Docket Item # 9
BAR CASE # 2009-0117

BAR Meeting
July 8, 2009

ISSUE: Alterations
APPLICANT: Valda Anderson
LOCATION: 123 S West Street
ZONE: CL

Figure 1. Photograph of front elevation and drawing of proposed cornice

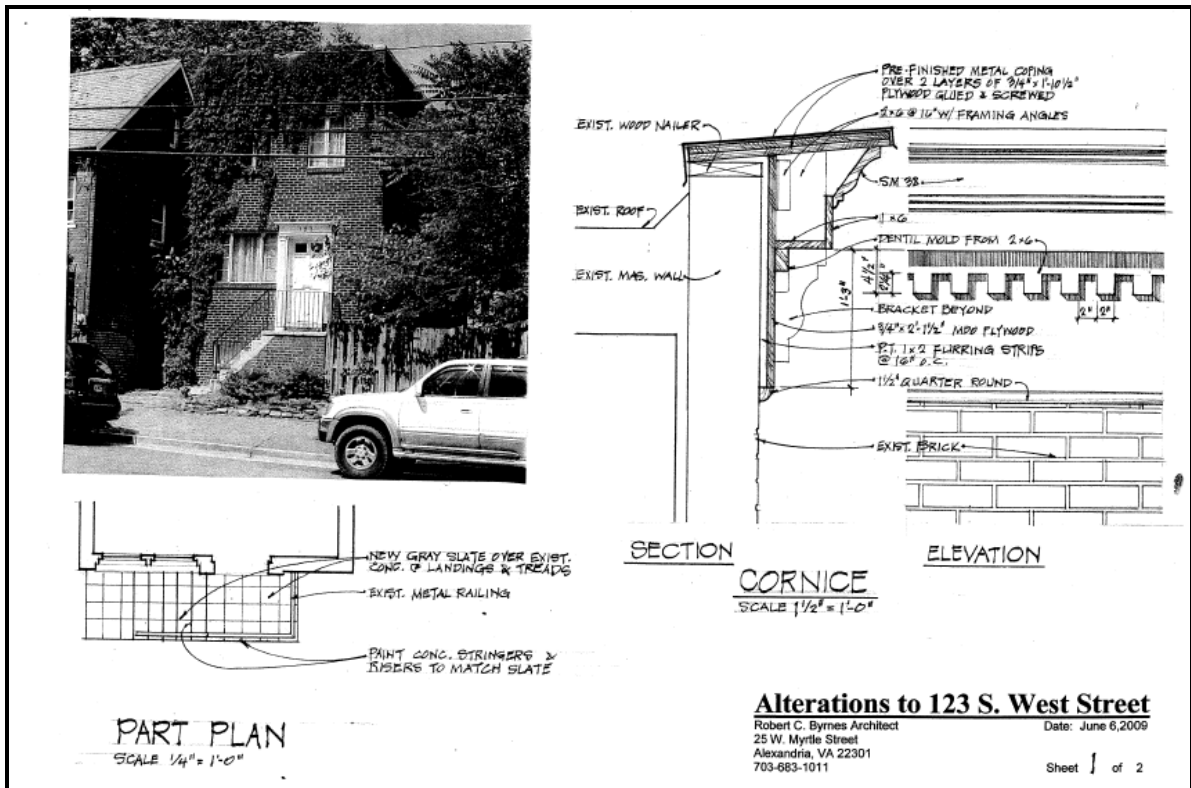
123 South West Street is a unique resource to the historic district in that it remains authentic to its original design without modification. Altering the facade by replacing the windows and adding Colonial Revival elements would strip the building of its historic integrity. Staff finds the addition of a cornice, with the objective of transforming a mid-twentieth century Modernist building into one of the mid-nineteenth century to be inappropriate. In addition, staff finds the installation of flag stone on the front stairs to be a further falsification of the buildings historic makeup and integrity. The lack of ornamentation at 123 South West Street is an intentional design aesthetic that should be preserved and not compromised. Therefore Staff recommends denial of the application.

IV. STAFF RECOMMENDATION: Staff recommends denial of the application.

Figure 2. Drawing of proposed alterations

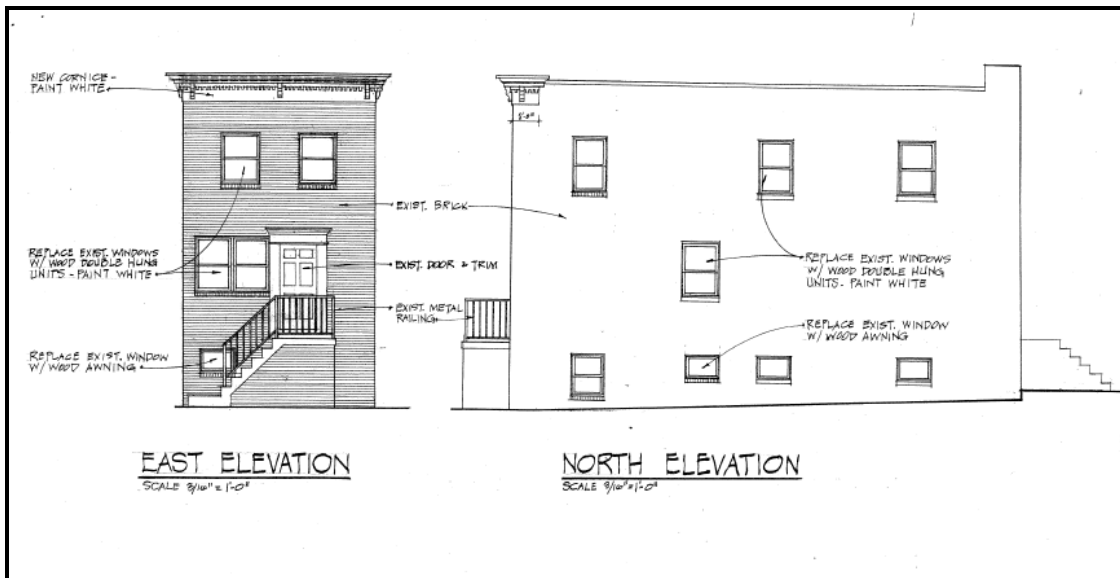
situation, Staff finds the replacement of the original metal casement windows to be inappropriate due to the fact that they are the character defining architectural element of the building. The brief continues to state, “other elements in assessing the relative importance of historic windows include the design of the windows and their relationship to the scale, proportion, detailing, and architectural style of the building...and less elaborate windows can also provide strong visual interest ...particularly in simple, unadorned industrial buildings.” Metal casement and wood double hung windows are not synonymous and replacing one for another as indicated in this application would destroy the buildings historic character. In addition, the windows appear to be in a condition in which they can be repaired and retained. According to the National Park Service, “moisture in the primary cause of corrosion in steel windows,” the solution for which is to, “add weather-stripping,” this would also make them more energy efficient.
